NARRATIVE FOR PLANNING REVIEW

AC Hotel – 1202 Summit Blvd; Frisco, CO PERMIT B-22-0054

NOTICE OF DECISION – ADMINISTRATIVE SITE PLAN (PLANNING COMMISSION REVIEW)

NATURE OF REQUEST: Planning File No. ADM-23-0003: An Administrative Site Plan Application for rooftop mechanical screening for B-22-0022, an interior remodel and porte-cochere remodel at 1202 North Summit Boulevard (aka Summit Suites Hotel).

SHEET A103 - ROOF PLAN

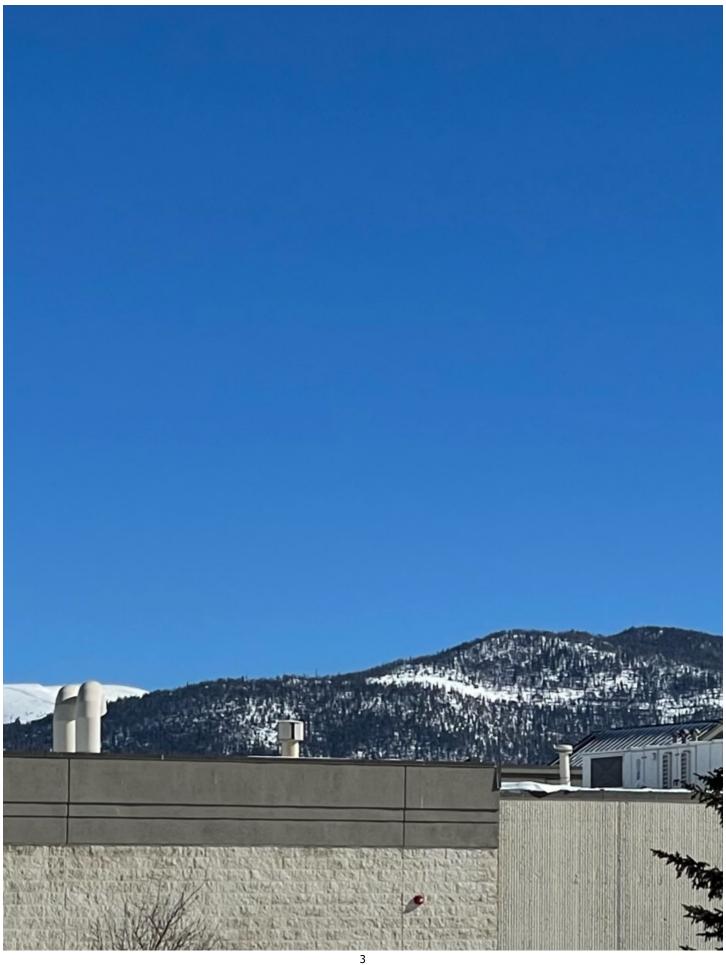
- Plan shows installed Mechanical systems on upper roof. Request was to provide screening around them per the UDC. UDC 180-6.21.3.D.4.g notes "All rooftop mechanical, electrical, and electronic equipment shall be screened in a manner that is compatible with and substantially similar to the colors and materials of the building or the roof." We are proposing enclosing the rooftop mechanical equipment with a roof-based screening system, with properties and characteristics similar to that of the building to the east of our site, the Kum-n-Go service station. See photos below; cut sheets for typical details are attached. The remaining ductwork on the roof shall be painted white.
- Plans show the addition of roof mounted guardrails at the standpipe locations at each perimeter stair tower of the roof. Cut Sheets are attached.

SOUTH ELEVATION - MECHANICAL VIEWSCAPES

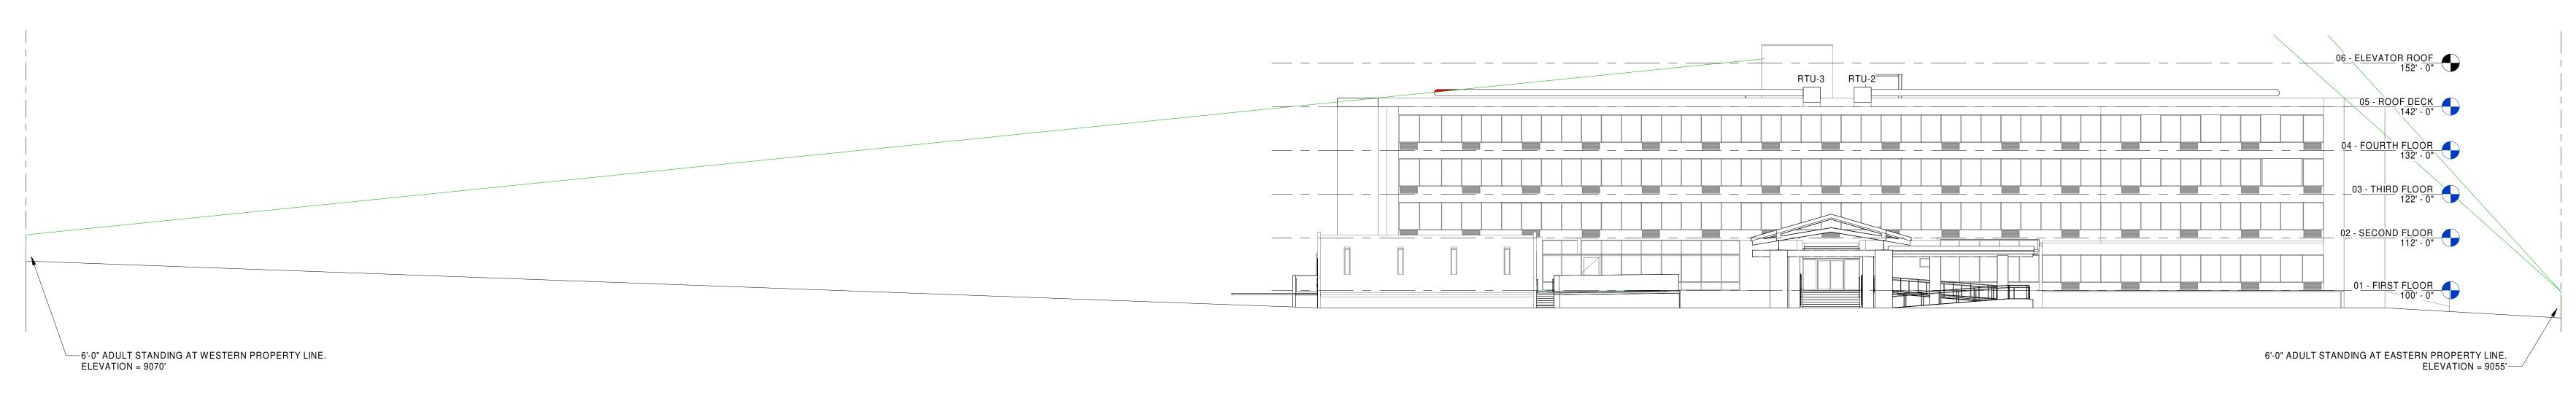
Neither Equipment Nor Ductwork is visible from Southern Elevation at Property Line

Modest visibility in SW Corner. Appellee has agreed to screen this southwest portion.

2 EAST ELEVATION - MECHANICAL VIEWSCAPES

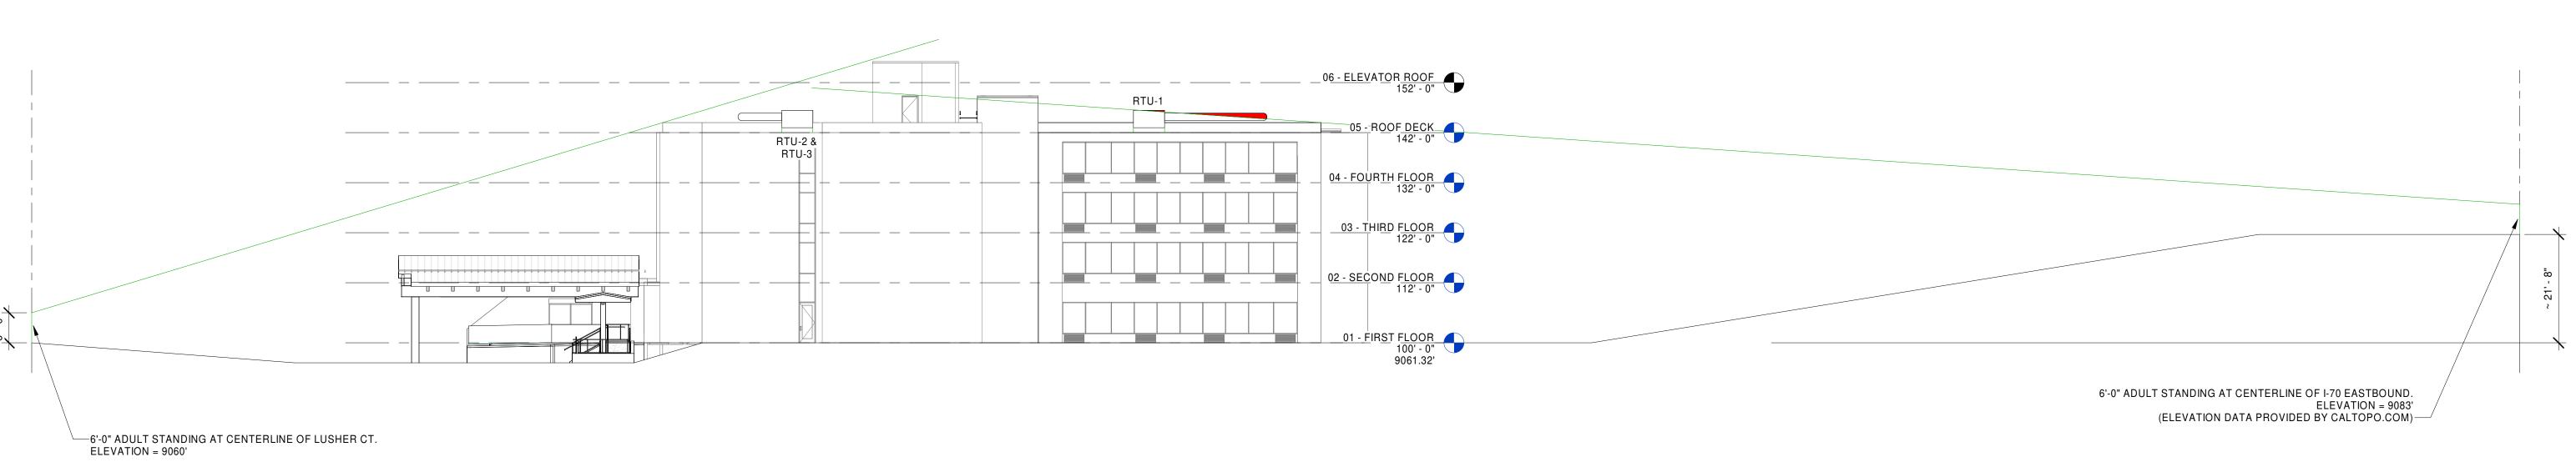
Neither Equipment Nor Ductwork is visible from Eastern Elevation at Property Line
